EVALUATION OF THE WIPP PROJECT'S COMPLIANCE
WITH THE EPA RADIATION PROTECTION STANDARDS
FOR DISPOSAL OF TRANSURANIC WASTE

Environmental Evaluation Group
7007 Wyoming Blvd., NE, Suite F-2
Albuquerque, New Mexico 87109

March 1998

Fig. 1. Location of WIPP Boreholes

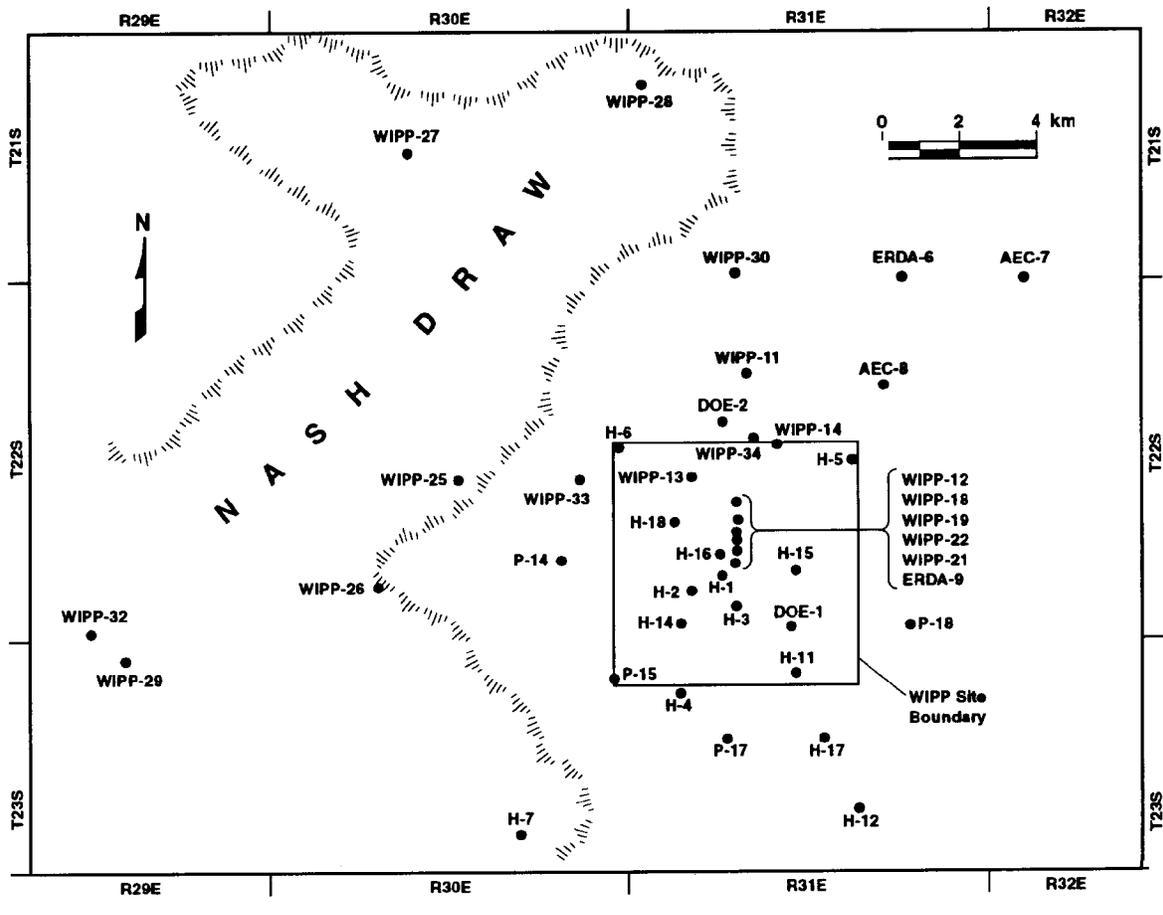
H-11 (see Fig. 1). While these high transmissivity zones are taken into account in the modeling of flow through the Rustler, there are remaining questions that have been raised by Leonard Konikow of the NAS WIPP Committee, and David Snow, regarding the nature of flow and transport through the Culebra, particular in the region directly above the repository, that have not been satisfactorily addressed in the proposed rule.

In summary, with respect to the karst question, while the EEG agrees that karst channels and sinkholes have not been found in the WIPP area east of the sink hole in which WIPP-33 (see Fig. 1) was drilled, we are less certain than the EPA about rejecting the possible effects of this phenomenon now and in the future. The EPA has concluded, “karst is not a problem at WIPP and that geologic evidence of the last approximately 500,000 years and results from DOE’s groundwater modeling indicate that future development of karst at the WIPP is not likely.” (U.S. EPA, 1997c, p. 58799). The EEG view is that while the effects of karst processes have not been identified at the WIPP site proper, the site is located in a karst region. Therefore, in considering the flow and transport through the Culebra, allowance should be made of this fact and the conceptual models, parameter values, and numerical modeling should be conducted with relatively conservative assumptions. A discussion of the issues of flow and transport through the Culebra is presented in Section 2.9 of this report.

Figure 2. Overall Mean of Normalized Releases for Modeling of increased solubilities using Nesquehonite and ‘No Backfill’ Values compared to CCA values.

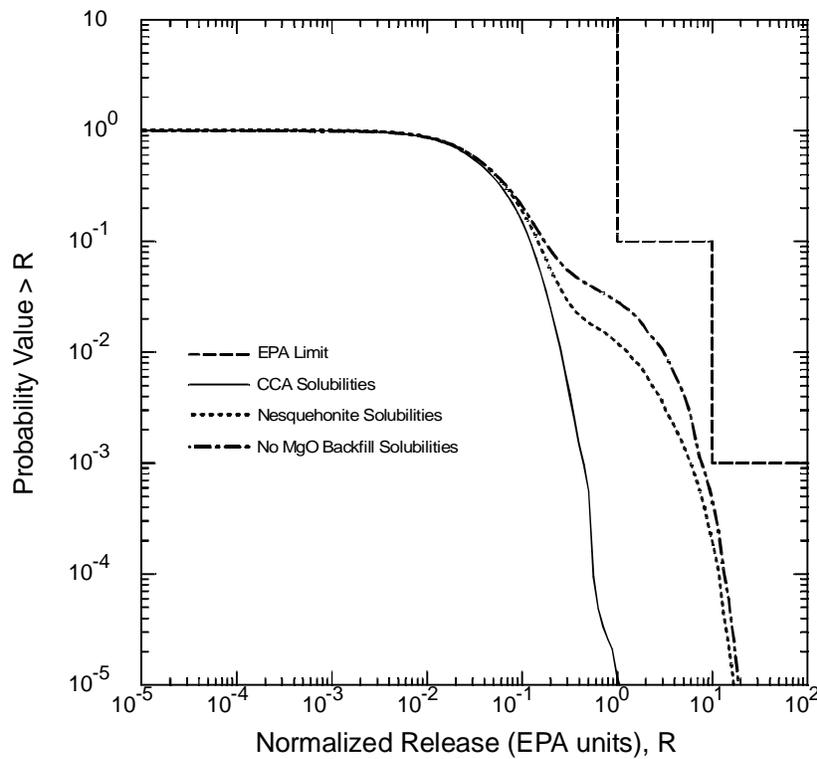
The consequences of higher solubilities, as seen in Figure 2 are quite high. The overall mean

release for the CCA and PAVT were 0.2 and 0.4 EPA u at 10^{-3} probability, respectively. The overall mean for the increased solubilities of nesquehonite and 'no backfill' are 6.0 and 8.0 EPA units at the 10^{-3} probability, respectively. The limit for compliance, according to 40 CFR Part 194 is 10 EPA units. Therefore, it appears that even high solubility values do not cause the disposal to be out of compliance with the EPA regulations. However, there is a deeper issue that one cannot dismiss, that is far less superficial than the previous statement. It deals with the consequences in small changes of solubility and variability in the actual values. Are we so certain that the solubilities of Plutonium or Uranium, in any oxidation state, are less than the values presented in the CCA or the PAVT? How did we arrive at these numbers? Are there experimental evidence to back up the claims made in the CCA that deals with the oxidation state analogy between Am+3 and Pu+3? Once one really delves into the reasoning behind many of the fixed numbers associated with these actinides, many deficiencies appear in the reasoning, and confidence in the values used to show compliance declines.

Figure 3. Contiguous Failed Volume as a Function of Increasing Waste Permeability for Different Waste Strengths With Initial Repository Pressure of 14.5 MPa.

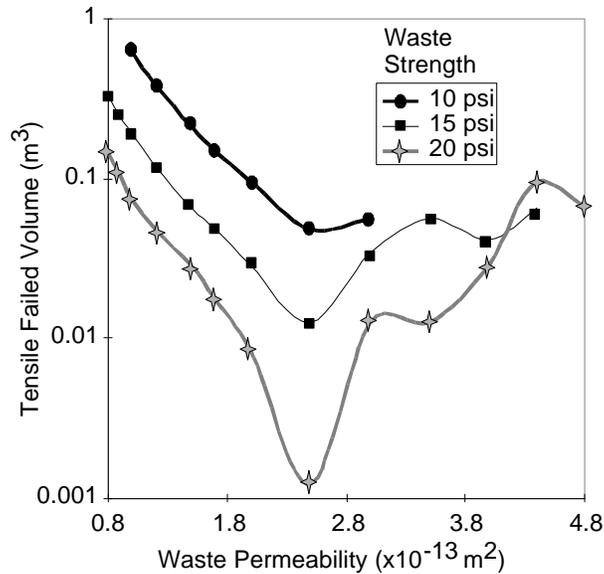
Figure 3 shows some interesting results as the waste permeability increases. All the waste strengths tested showed an exponentially decreasing failed volume, up to a permeability of $2.5 \times 10^{-13} \text{ m}^2$. Permeabilities above this value cause larger failed volumes than values below it. The upper limit on permeability shows that the code is reliable to $2.5 \times 10^{-15} \text{ m}^2$ for waste strengths that were measured in the report by Hansen et al. (1997) and initial repository pressure of 14.5 MPa. The lower permeability limit is $1.0 \times 10^{-13} \text{ m}^2$ for 10 psi waste strength, and decreases to $0.8 \times 10^{-13} \text{ m}^2$ for waste strengths of 15 and 20 psi.

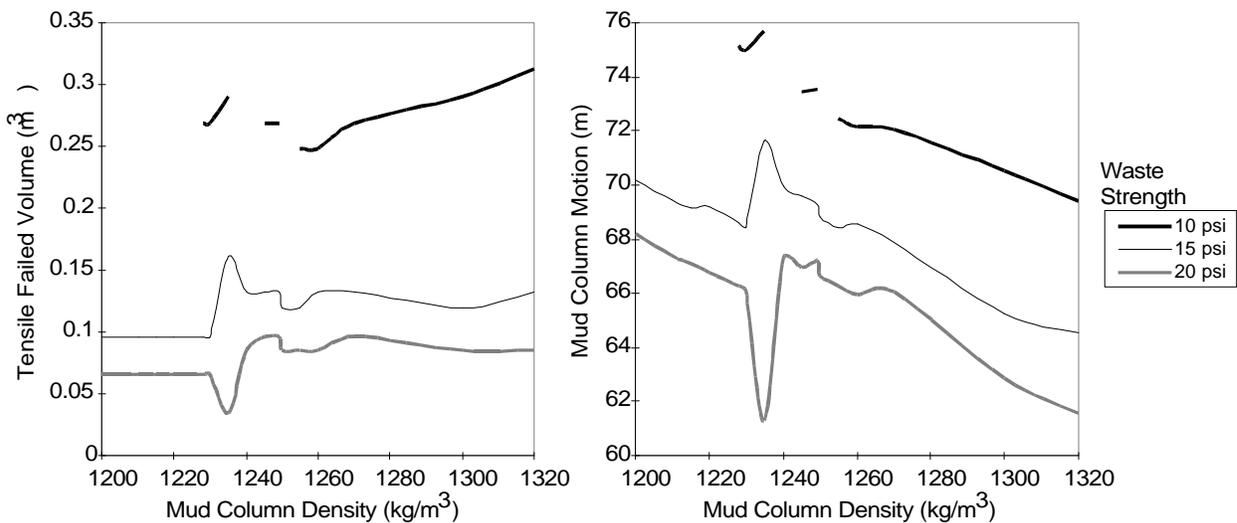
Figure 4 shows the results of varying the parameter from 1200 to 1320 kg/m³ for a 10 second simulation and an initial repository pressure of 14.8 MPa. The figure shows three curves of different waste strength, with all other parameters remaining the same as used in the Base Case simulation. The most outstanding feature of Figure 4 is the disjointed curve of failed waste (left) and mud motion (right) of the 10 psi tensile waste strength simulation. The code had trouble calculating failed waste for mud densities below 1228 kg/m³, resulting in the cascading affect described above. The code also had trouble at 1240 and 1250 kg/m³, and if results were plotted for these densities (failed waste and mud motion), sharp spikes would exist in the curve.

For the higher waste strengths (and subsequently lower repository pressures) of 15 and 20 psi, the mud density simulations were able to calculate failed volumes for all density values investigated. However, the results seemed almost as unreliable as the lower waste strength. Though a trend can be seen in the failed volume and mud motion, variances from those trends are high. Both graphs in Figure 4. show trouble with densities between 1230 to 1270 kg/m³.

Figure 7. Failure Volume (m^3) vs Time (s) for Different Waste Permeabilities. The results are from GASOUT with the option of 'failed material removal' turned off.

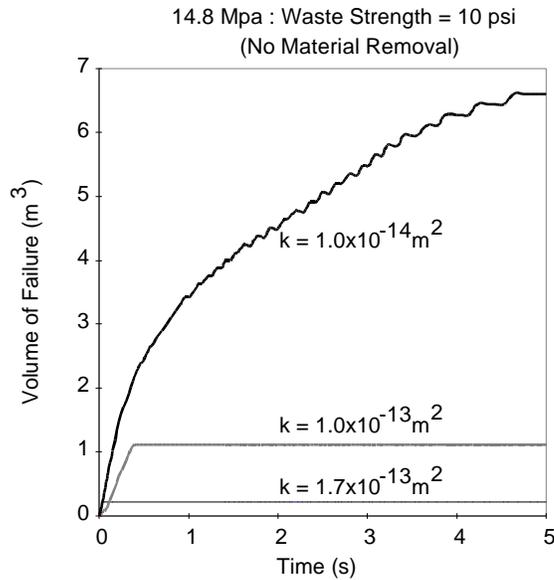
For an extreme example of the above analogy, Figure 7 shows radial distance of potential failure at permeabilities of 1.7×10^{-13} and 1×10^{-14} m² for pressures at 14.8 MPa without material removal. Potential failure was extrapolated from the effective stresses that would exist in non-failed material. The repository pressure was set at 14.8 MPa and waste strength at 10 psi for the experiments in Figure 7.

The figure clearly shows that when permeability is lower than assumed in the CCA then releases will be higher than assumed from the investigation in Hansen et al. (1997). The maximum radial failure at a permeability of 1×10^{-14} m² is 1.17 m, equating to an uncompacted spalled volume of 6.6 m³. It is believed that when permeability is even lower than the lowest value presented in Figure 7, the releases could be higher. However, the code has difficulties with oscillations in pressures at lower permeabilities, and confidence in results is low.

The results of Figure 7 must be kept in context. When material is not removed during the pore pressure calculations (and subsequently total overburden stress), the code does not redistribute values at the new boundary. Instead, the pore pressures decrease in that region, hence lowering the possibility of new failed material. Therefore, Figure 7 actually underestimates the potential effect of failure, and higher volumes will result if the material is removed. These calculations are not possible with GASOUT, with reasons explained from the sensitivity analysis with the code.

Figure 11. Effective Radial Stress As A Function Of Radial Distance For The EPA's Air Drilling Analysis.

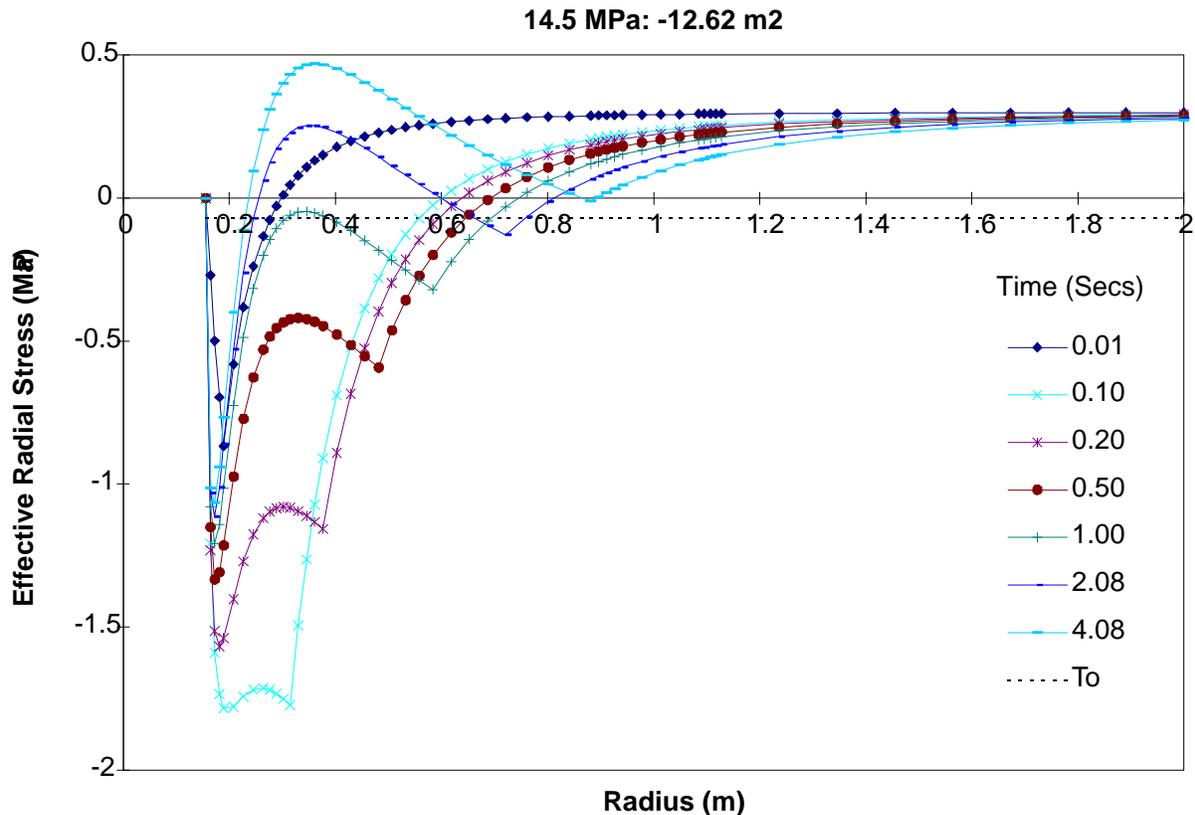
The results of air drilling from the EPA's analysis at WIPP is reproduced here in Figure 11. The figure shows effective stress versus radial distance within the repository at several times during the simulation. The EPA judged failure in this figure by estimating the point at which the effective stress is less than the strength of the material (indicating high pore pressure). This point is at 1 second from the beginning of the simulation, with a radial failure distance of 0.69 m (1.4 m³ of uncompacted waste). After 1 second of simulation time, the pore pressure in the waste near the cavity begins to decrease, and the effective stress moves upwards (increases positively) towards the region of higher total stress.

Intuitively, the results shown in Figure 11 would raise questions about the behavior of the system. Why does the effective stress sharply decrease from 0.01 seconds to 0.1 seconds then gradually rise throughout the remainder of the simulation? Does the system stop predicting failure after 1 second? What is the effect of tangential stresses in the waste? How does the system respond to varying repository parameters? All of these questions are relevant to the understanding of the Quasi-Static model and to the prediction of stresses in the waste from an air drilling event.

Figure 12. Effective Stress, Total Stress, and Pore Pressure Profiles in the waste at three independent times from the EPA’s Analysis of Air Drilling.

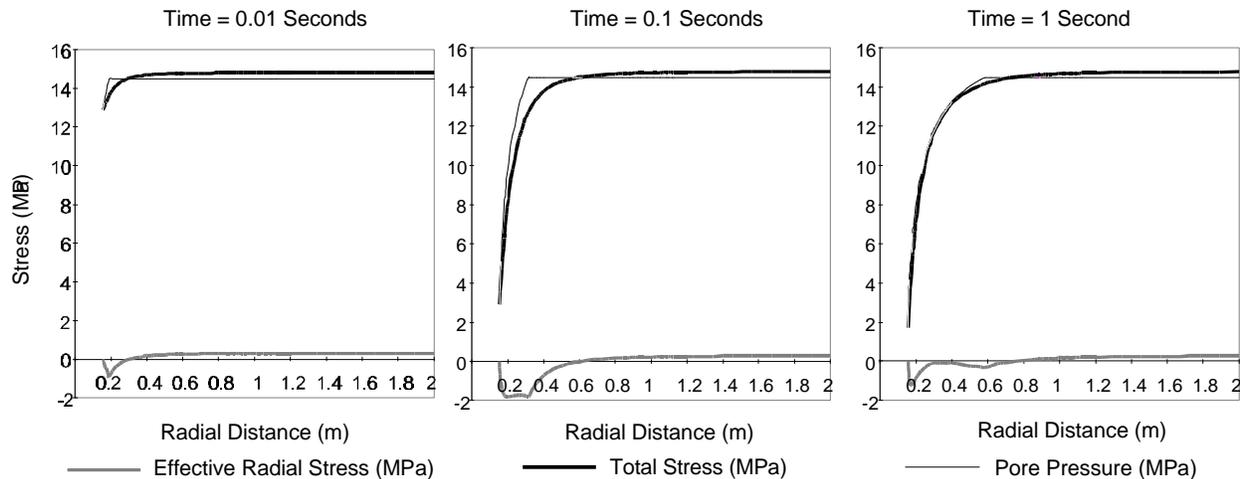
The effective stress is simply the difference in the calculated total stress and calculated pore pressure. Figure 12 shows the relationship between these quantities for three separate times for the EPA's analysis of air drilling. The left plot shows the first time step, at 0.01 seconds from time of intrusion. One can see immediately that waste failure occurs due to a slightly higher pore pressure, with the radius of failure being 0.27 m. The relatively large failure at this time is due to the unsmooth function of the pore pressure in the waste, which carries over to the effective stress. The same can be seen the two other plots of 0.1 and 1 second from intrusion time. The effects of the unsmooth pore pressure profile average out as the time from intrusion increases, but is one the reasons for increase in effective stress at later times.

The code also only approximates the pore pressures in the repository by assuming steady flow. As seen in Figure 12 (above), the steady flow assumption causes the pore pressure profile to be unsmooth. This characteristic, when combined with total stress of the overburden rock, produces oddly varying effective stresses in the waste. This shows that the code produces unreliable results for an air drilling scenario. When effective stresses are compared to the results of a code that calculates the time-dependent flow and pore pressures (Figure 13, above), the effective stresses are much lower (higher in the negative direction) than the Quasi-Static model at early times. Beyond the first couple of time steps, the code starts to be less accurate, and pore pressures begin to decrease in waste that should have been removed.

Figure 14. Yield Potential for EPA Air Drilling Analysis. The Figure Represents Equation 2 (above) vs. Radial Distance. Yield Will Occur When the Potential is Greater than Zero.

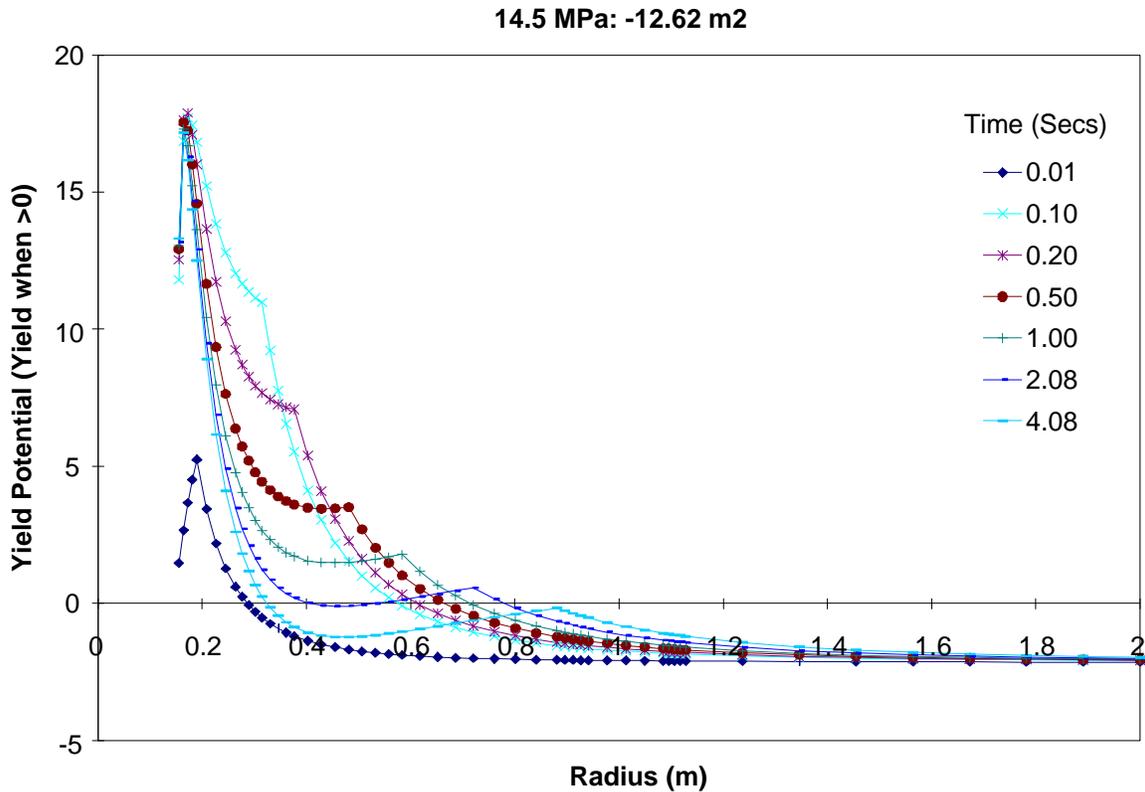
Figure 14 shows the results of Equation 2.5-2 plotted against radial distance. The first observation is that there is potential for yield out to 2 seconds from the time of intrusion. The yield crosses the axis at approximately 0.8 m, resulting in an uncompacted volume of 2.1 m³. This is an increase of 33% from the initial estimate stated in the EPA's analysis. The curves also seem to be highly influenced by the discontinuity in pore pressure calculations, and can be seen in Figure 14 by the second peak in the curve as radial distance increases. When compared to the yield potential calculated from GasOut, which calculates a smooth function of pore pressure, the limit for yield is 0.7 m at 0.1 seconds from intrusion (as compared to 0.6 m from the Quasi-Static model). After this time the yield is essentially zero.

Figure 15. Effective Radial Stress As A Function Of Radial Distance For An Increased Pressure For The Air Drilling Scenario.

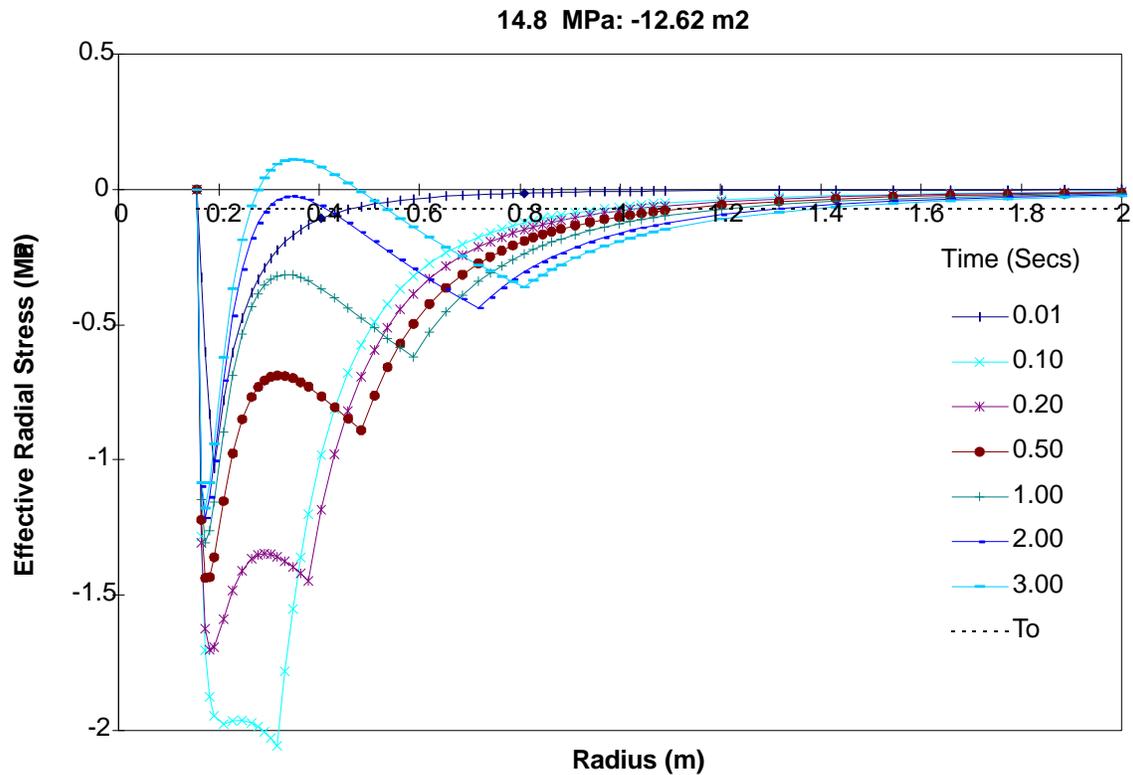
To demonstrate the response of the model to different input assumptions, Figure 15 shows a simulation in which the repository is increased from the nominal 14.5 MPa that was used in the EPA analysis to 14.8 MPa. The higher pressure is the maximum pressure that the repository will

sustain for long periods of time, and is the lithostatic pressure of the overburden rock. If gas pressures are above lithostatic, the weak stratigraphic layers will fracture until sufficient energy is released and the pressure returns to the minimum fracturing pressure. The results of Figure 15 are astounding. The figure shows that a nominal increase in pressure will significantly increase potential releases. At 1 second after initial intrusion, the radial distance of failure is 1.22 m (7.58 m³ of uncompacted waste). Although not shown, the waste will continue to fail during the entire 9 second simulation, in which the radial distance increases to approximately 1.65 m (19.1 m³ of uncompacted waste). These volumes are greater than the 4.0 m³ maximum calculated in the CCA, and perhaps would have an impact on the CCDF calculations if air drilling scenarios were considered in the CCA.

Fig. 19. Comparison of Approved Injection Pressures For Salt Water Disposal Well Versus Oil Field Water Flood Wells Near WIPP.

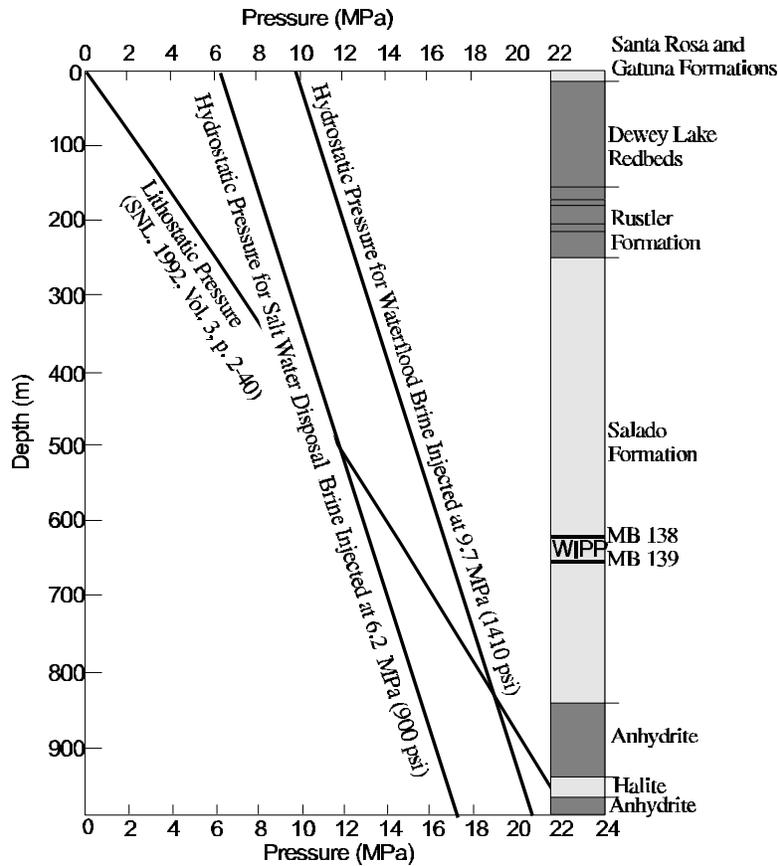
WIPP. Figure 19 compares the maximum approved disposal pressure for two wells one mile to the east of the WIPP Site. EEG is not suggesting that either of these wells are leaking. But EEG notes that in the event of a leak near WIPP current approved salt water disposal pressures are not sufficient at the repository horizon to exceed the lithostatic pressure. Only a leak in the waterflood well would be of concern to the repository. This is an inherent result of the greater vertical distance to the oil producing horizons. The DOE and EPA rationale appears to be more appropriate for the more shallow oil and gas reservoirs in the Vacuum Field area and the Rhodes Yates area and not suitable for the WIPP area. Presumably, carbon dioxide for enhanced oil recovery would be injected into the deeper oil producing zones and at sufficient pressures to maintain a miscible displacement. Hence, given the observation above, EPA can not conclude that the salt water disposal well analyses captures the CO₂ flooding scenario.
